Project Name: Spot Bar
Project Address: 859 Randolph Avenue
Suite #/Campus: N/A
City Name: St. Paul
Applicant: Bruce Pastorius, Collective Carpentry

CITY OF ST. PAUL
REVIEWED FOR CODE COMPLIANCE
ARCHITECTURAL V-21-2094
DATE 12/13/2021 MD
STRUCTURAL _____
DATE _____

REVISED PLAN 12/20/2021:
REDUCED SIZE OF PROPOSED
DECK TO 20' x 20'

SPOT BAR
DECK
SIZE

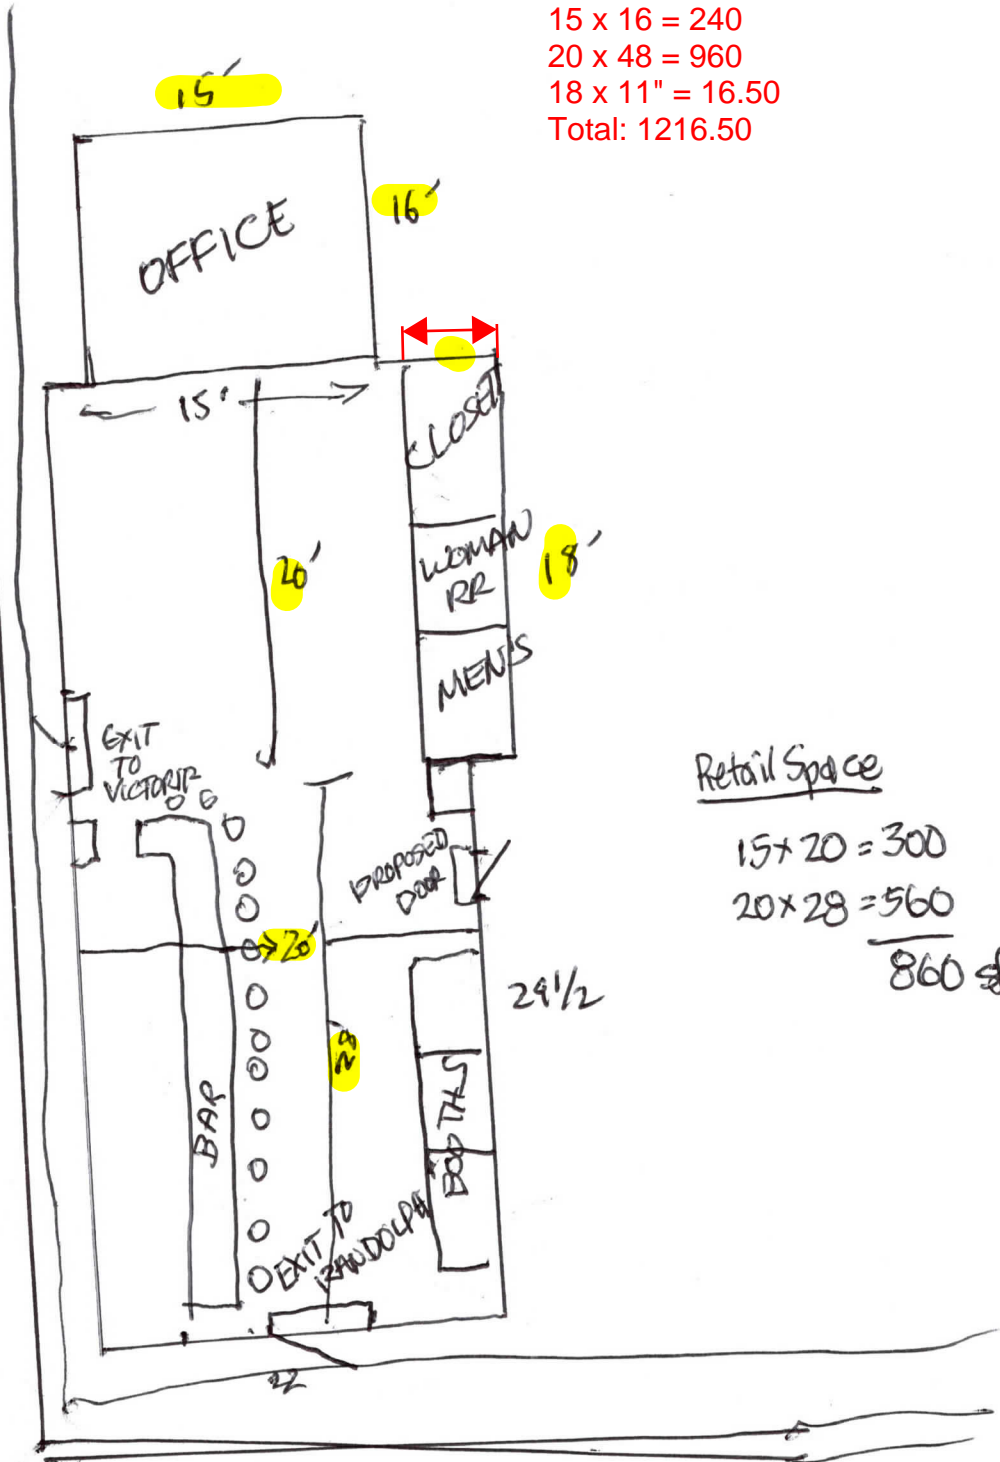
CHANGED TO 20x20 DECK WHICH IS SMALLER THAN ORIGINAL DECK PLAN, OK FOR PLAN REVIEW, STILL NO SAC OWED.

SPOT BAR 859 RANDOLPH AVE SP. PAUL MN 55102 MERIDITH JOOLE	OUTDOOR LOUNGE 8'x19' DECK 10'x30' DECK 37 LF PRIVACY FENCE P.I
---	---

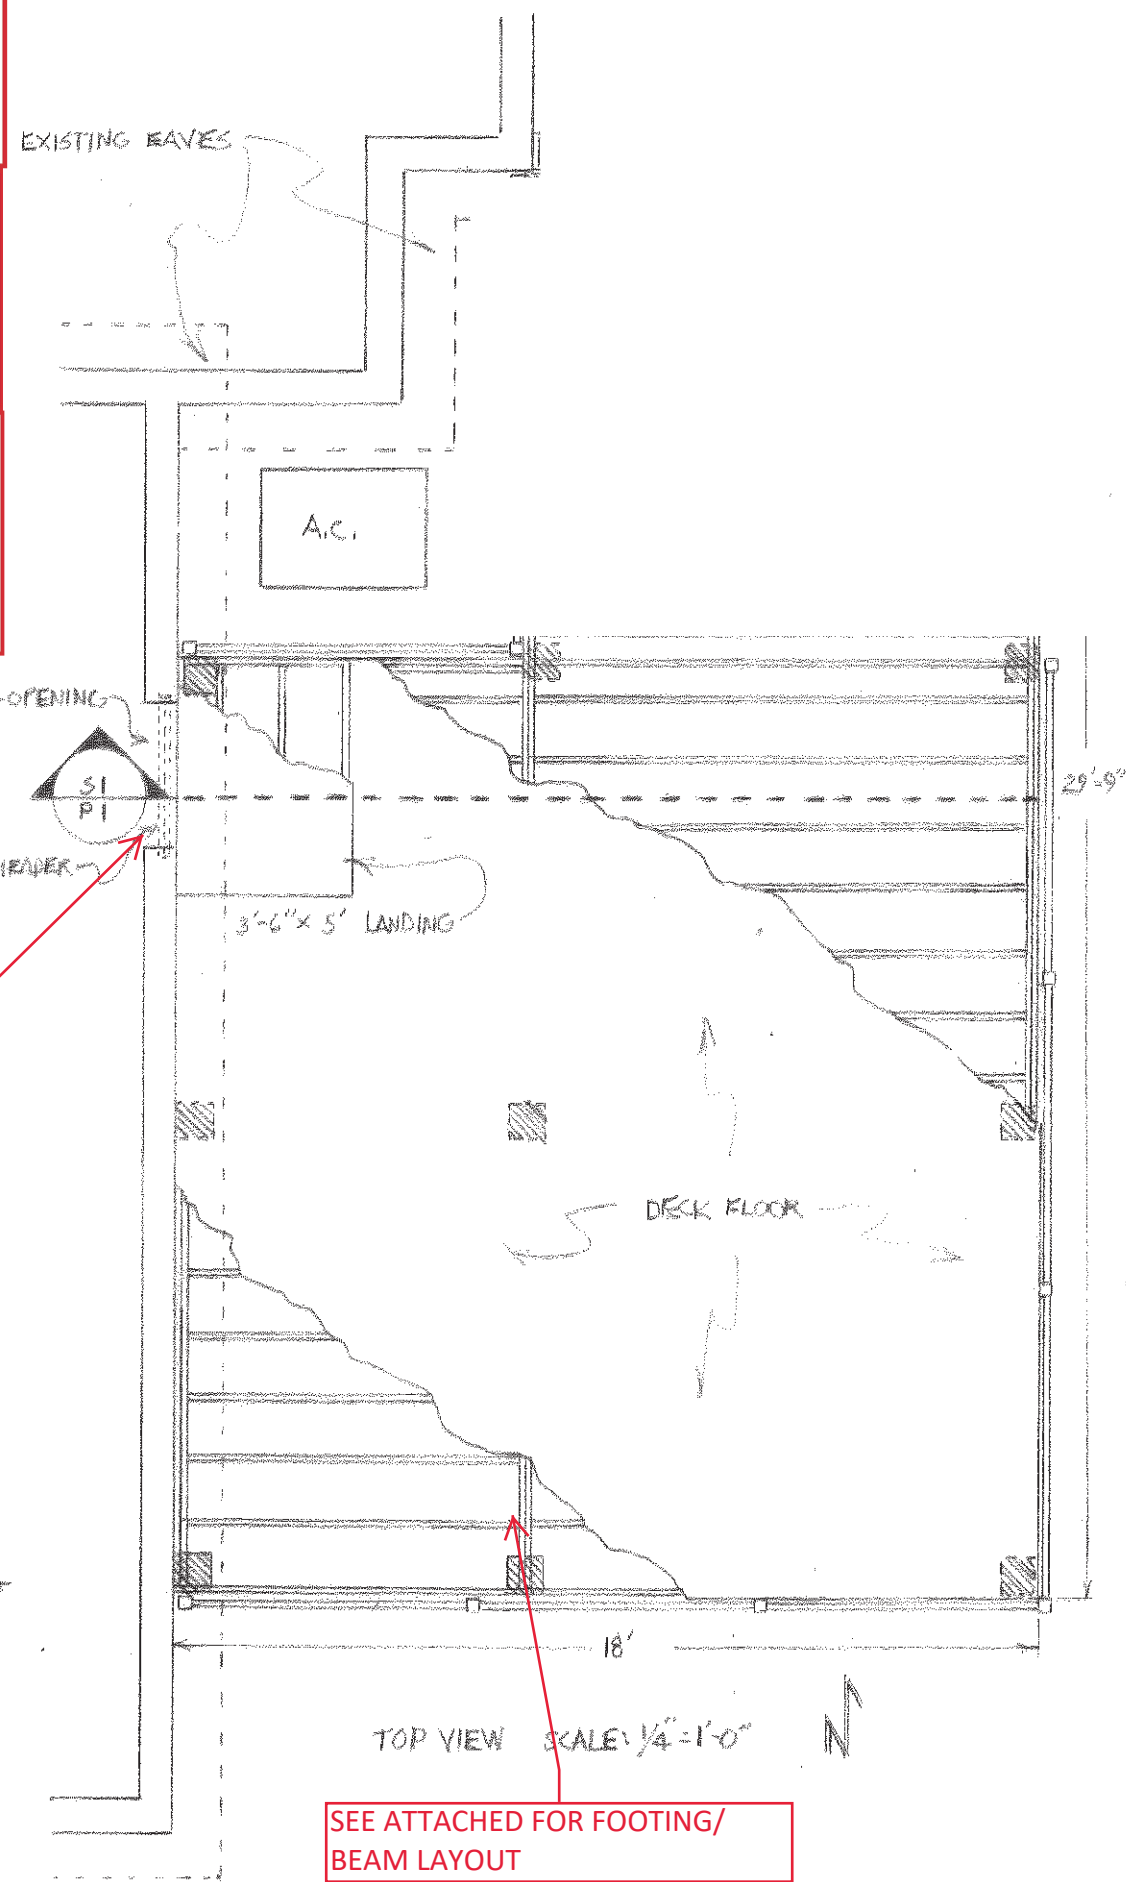
MN ACCESSIBILITY CODE COMPLIANCE REQUIRED. INSTALL EXACTLY PER CODE. ALL ERRORS MUST BE CORRECTED.

NO LANDING HERE DECK TO BE BOUT 22" OFF THE GROUND AND NO MORE THAN 3/4" BELOW THE INTERIOR FLOOR SURFACE FOR ACCESSIBILITY.

SEE ATTACHED SEATING PLAN, OCCUPANT LOAD OF 20X20 DECK WITH TABLES/CHAIRS IS LESS THAN 50' DOOR SWING CAN GO EITHER WAY.

SEE ATTACHED FOR FOOTING/ BEAM LAYOUT

SECTION SI PI SCALE: 1/2" = 1'-0"

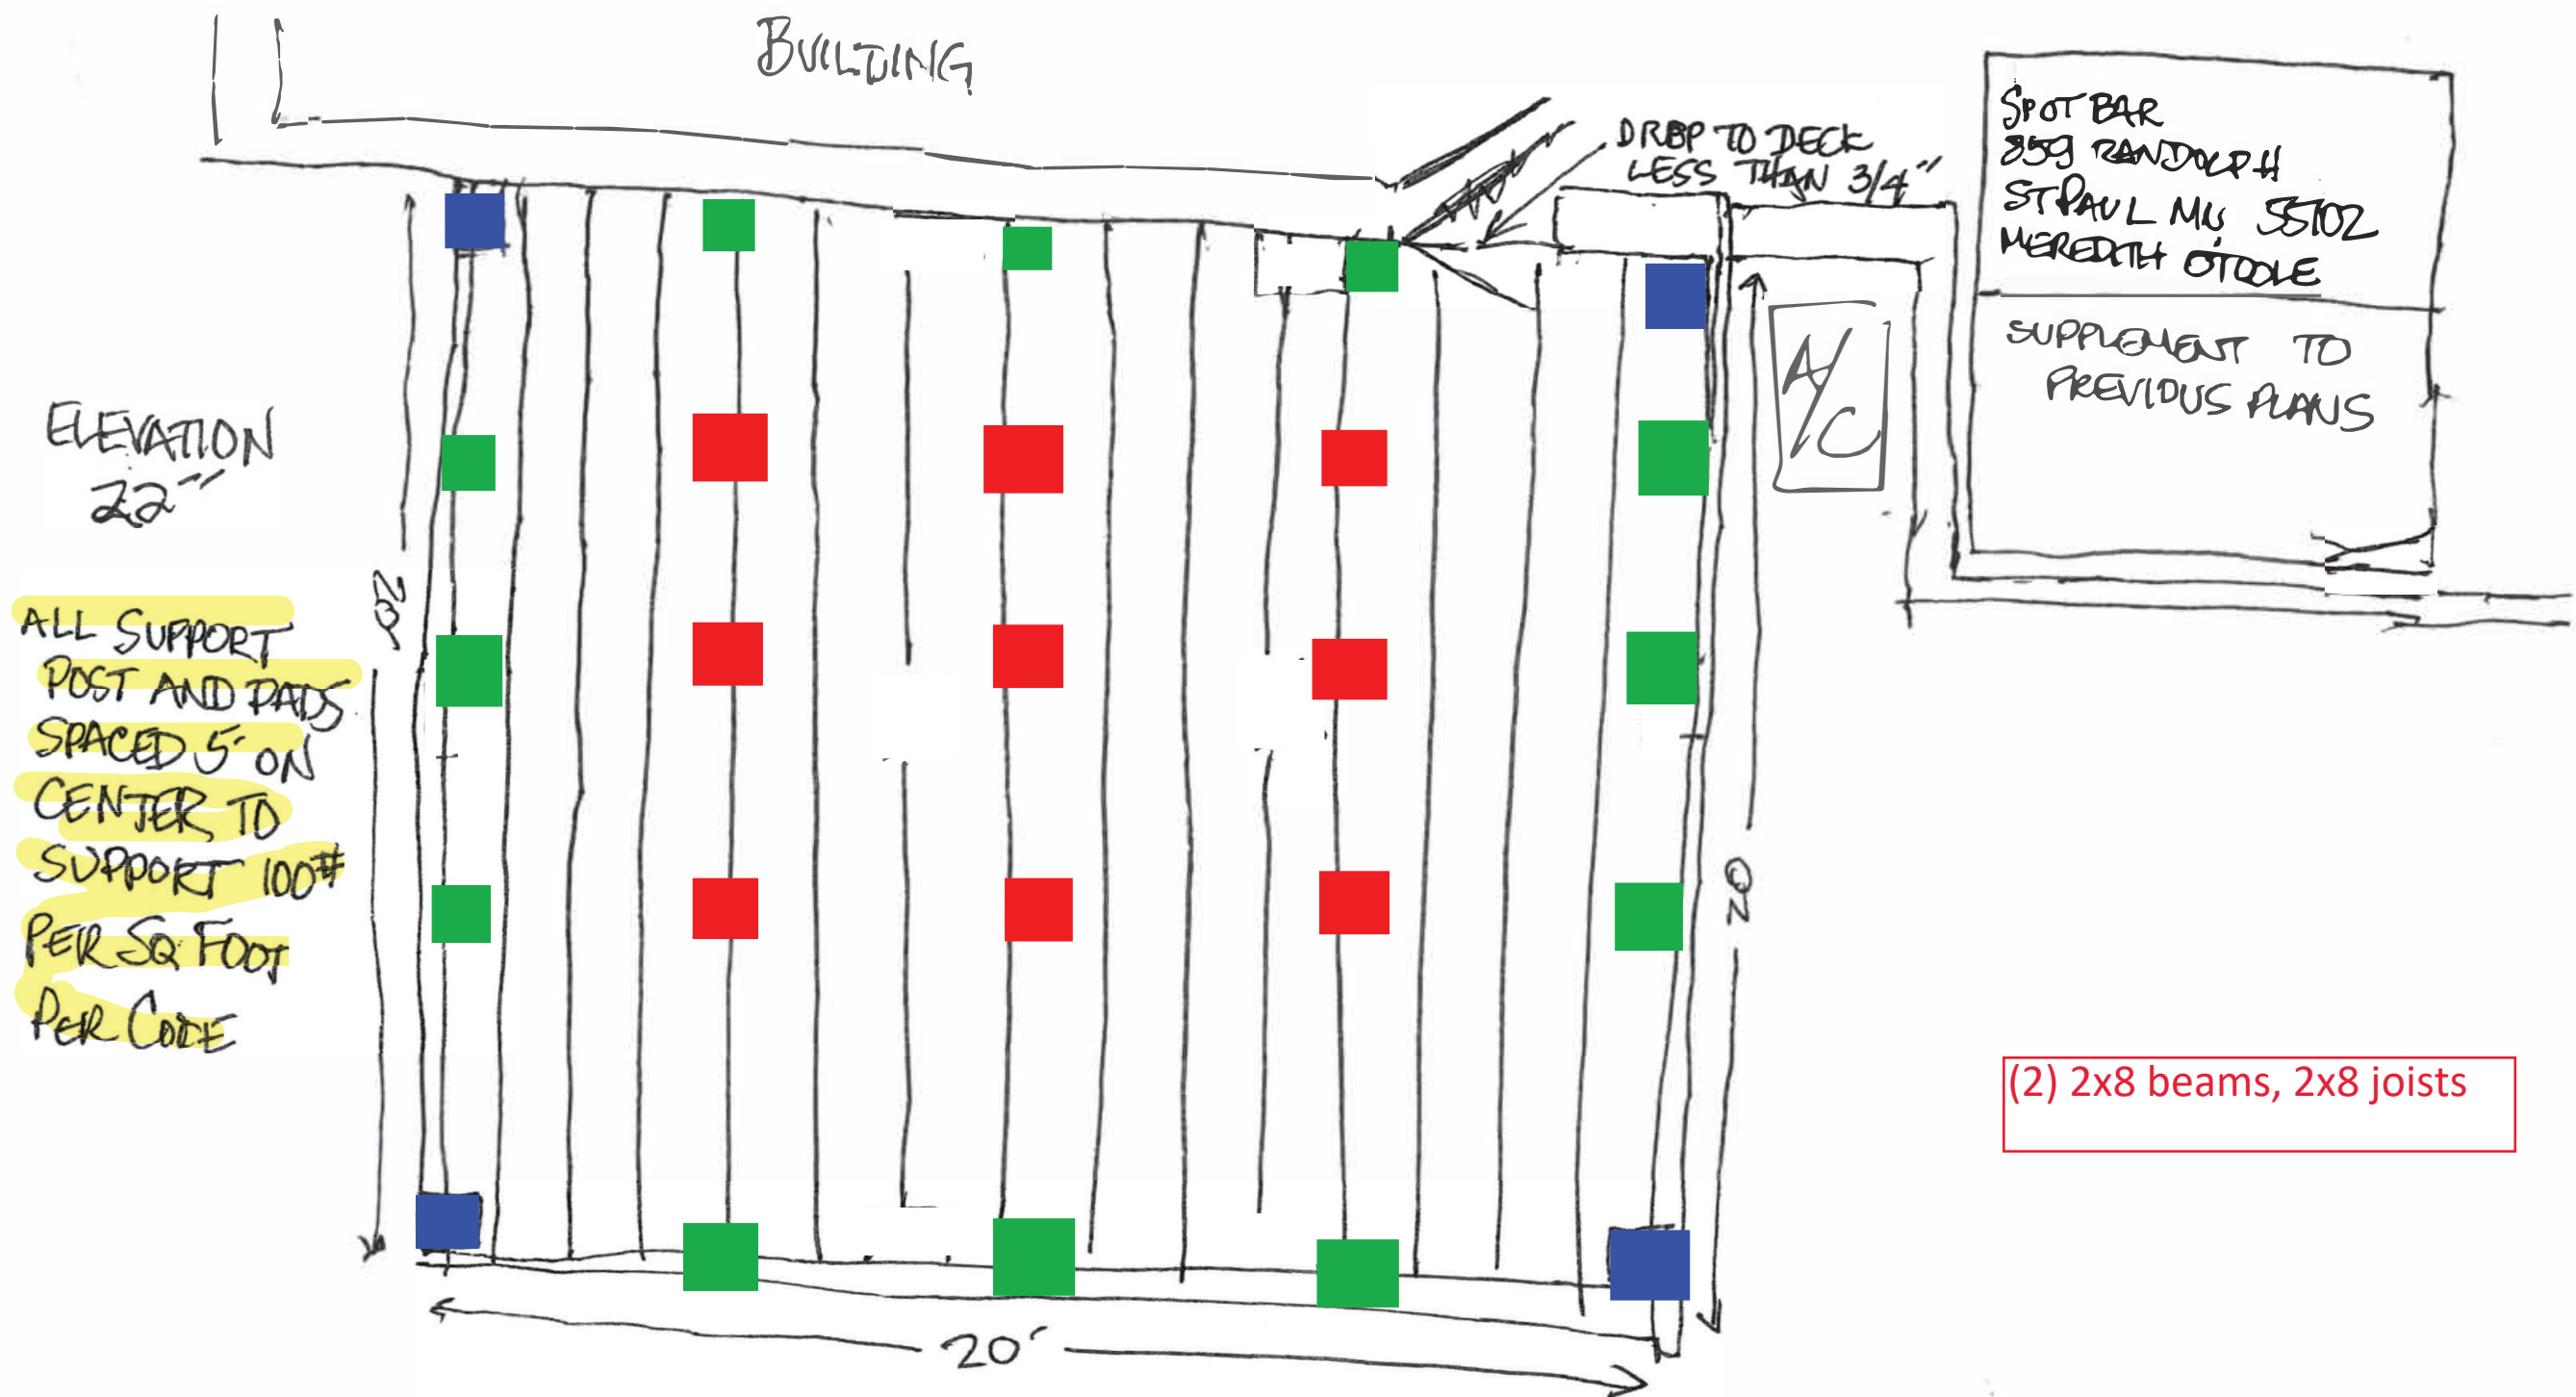
ALTERNATE ACCEPTABLE FOOTING LAYOUT: FOR A DECK USING 8"x8" PRECAST FOOTINGS, TRIBUTARY AREA FOR EACH FOOTING WOULD BE A MAXIMUM OF 9 SQUARE FEET (FOOTINGS WOULD NEED TO BE IN PLACE EVERY 3' FEET IN A GRID PATTERN MINIMUM OR EQUIVELANT).

TOP VIEW SCALE: 1/4" = 1'-0"

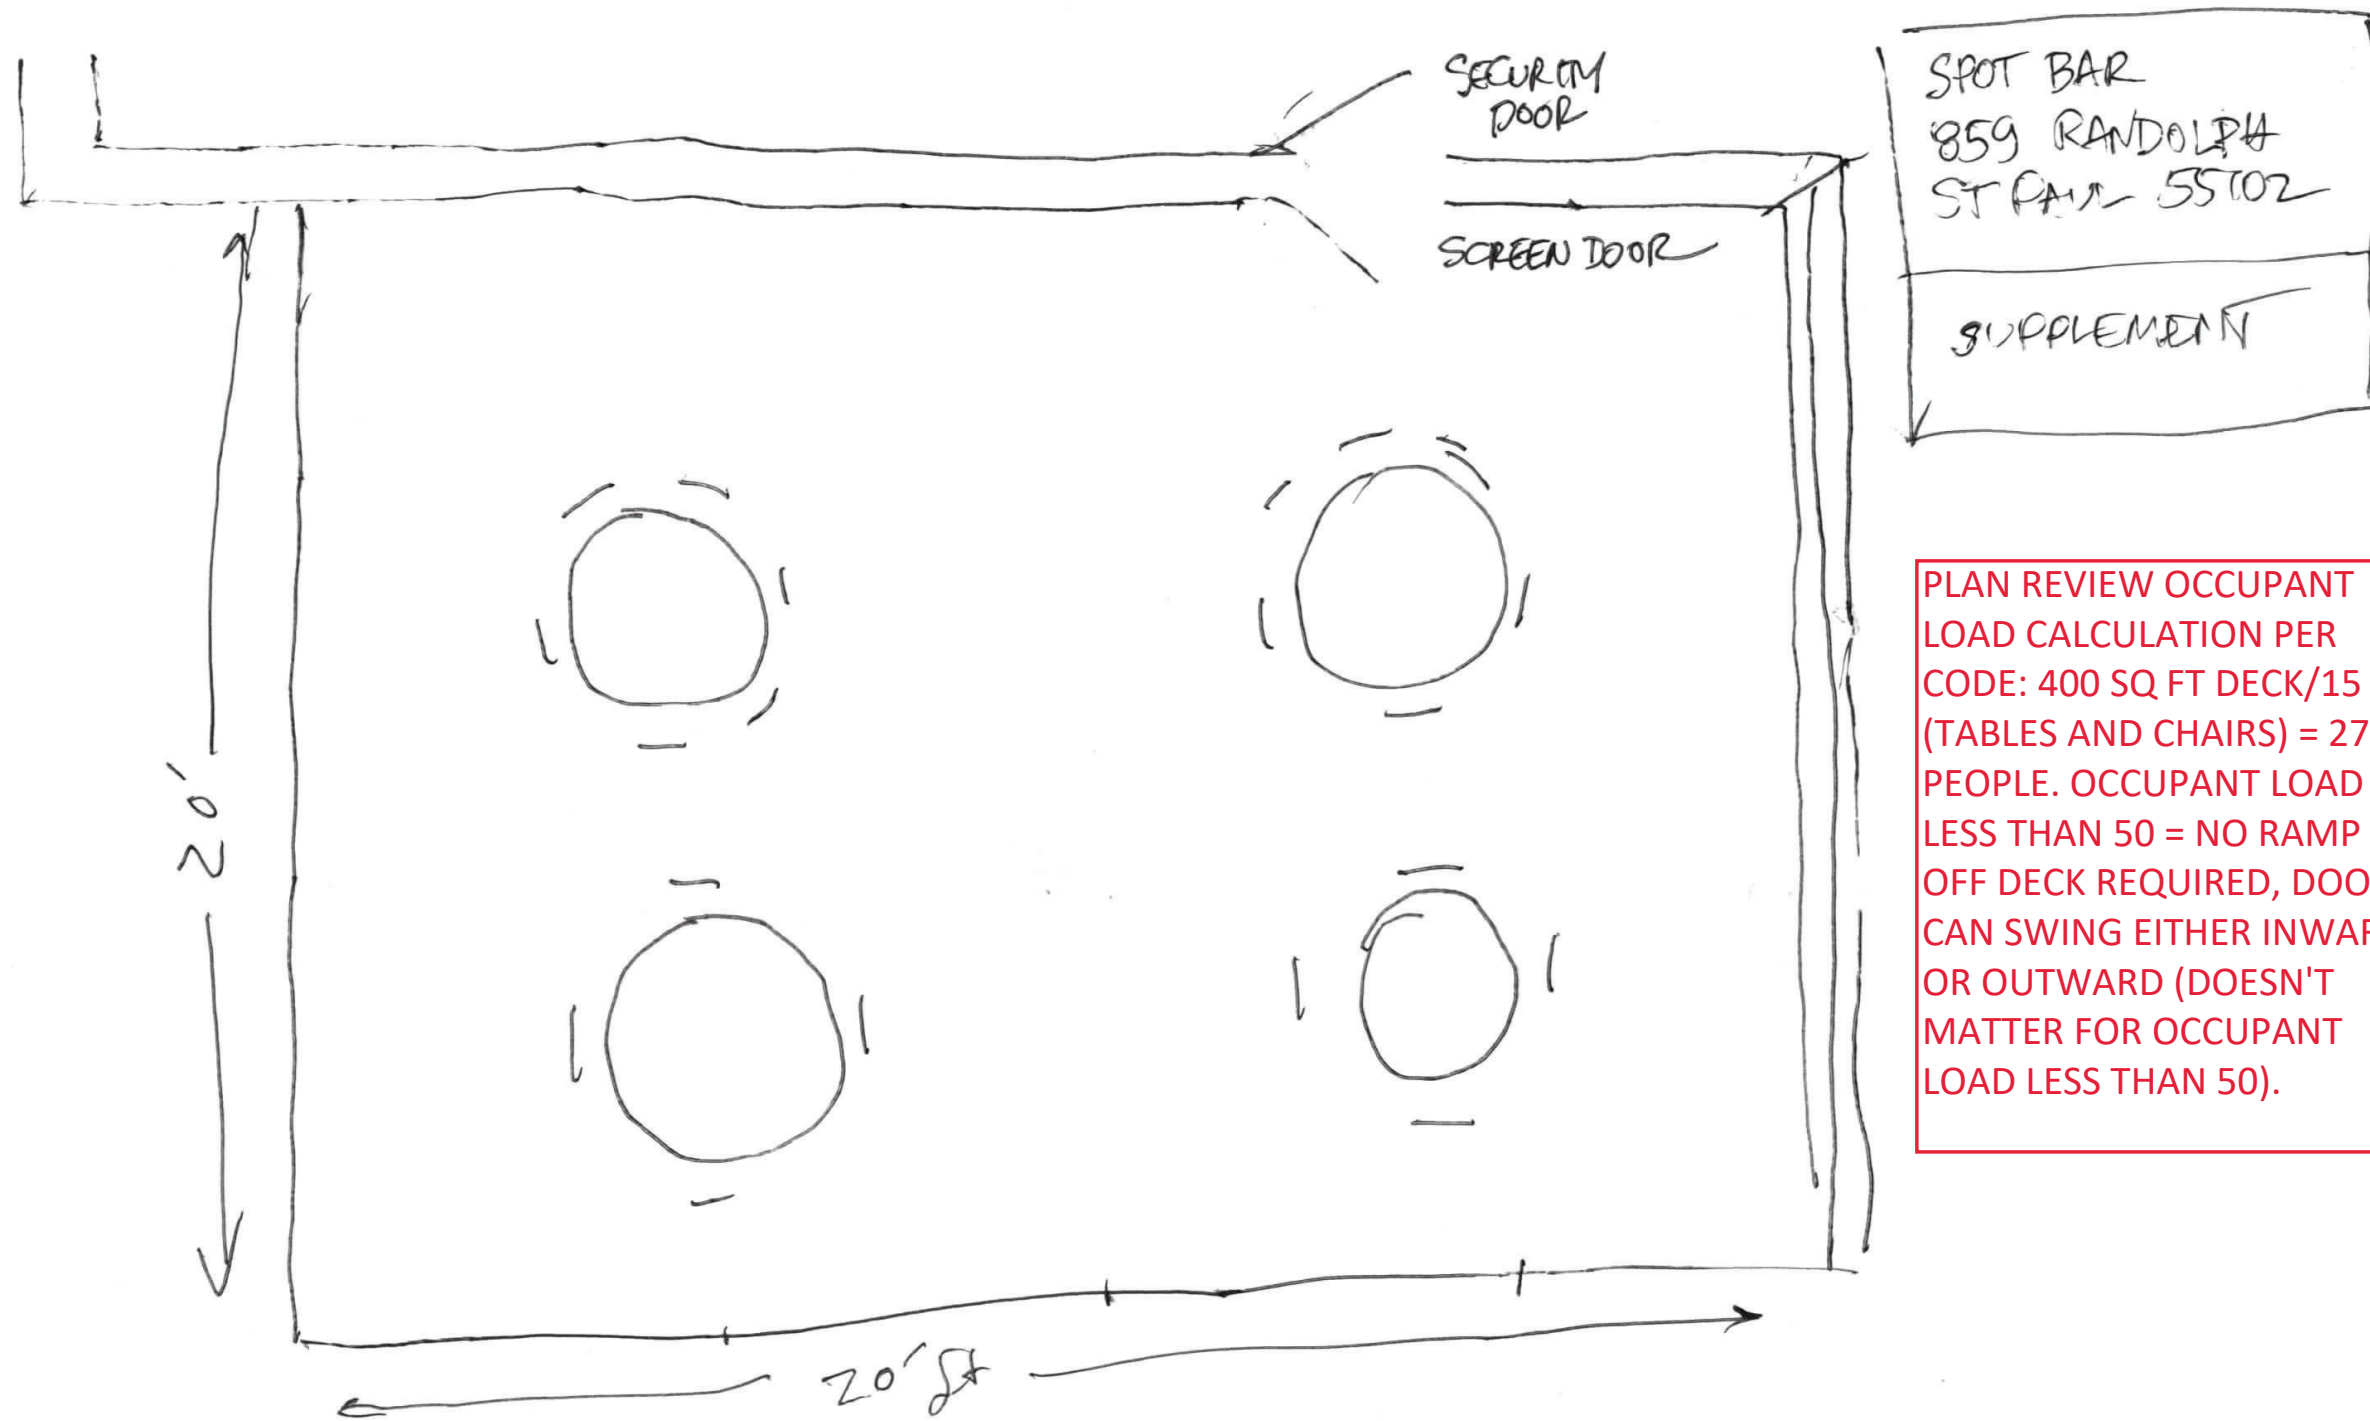
- = RED FOOTINGS; SUPPORTING 2500 LBS, SIZE 14"X 14" PAD FOOTING MINIMUM
- = BLUE CORNER FOOTINGS, SUPPORTING 625 LBS, 8" X 8" PAD FOOTING MINIMUM
- = GREEN OUTER FOOTINGS, SUPPORTING 1250 LBS, 11"X 11" PAD FOOTING MINIMUM
